REMARKS

FIG. 1

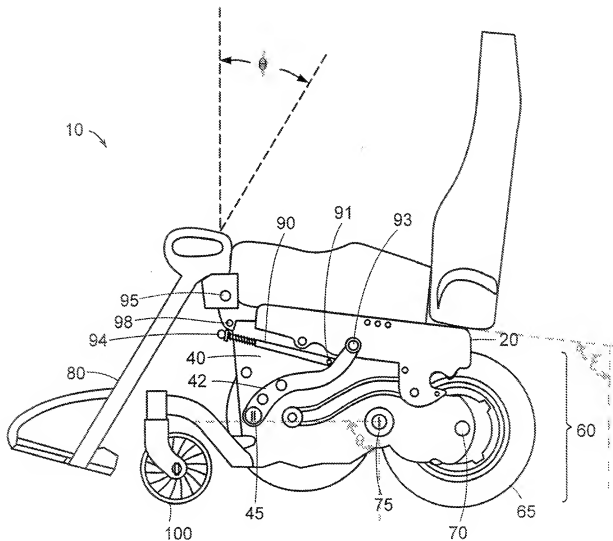
In paragraph 2 of the previous Office Action, the drawings were also objected as failing to show various features of the claims. A new substitute Fig. 1 is submitted with this application showing the base pivot angle θ and support pivot angle ζ . The support pivot axis was already shown as element 45 and the surface contacting module was already shown as element 60. Claims referring to other elements missing from the drawings have been canceled.

page 6, lines 7 and 10 has been corrected by amending Fig. 1 to show the rest pivot angle with the symbol ϕ rather than as θ .
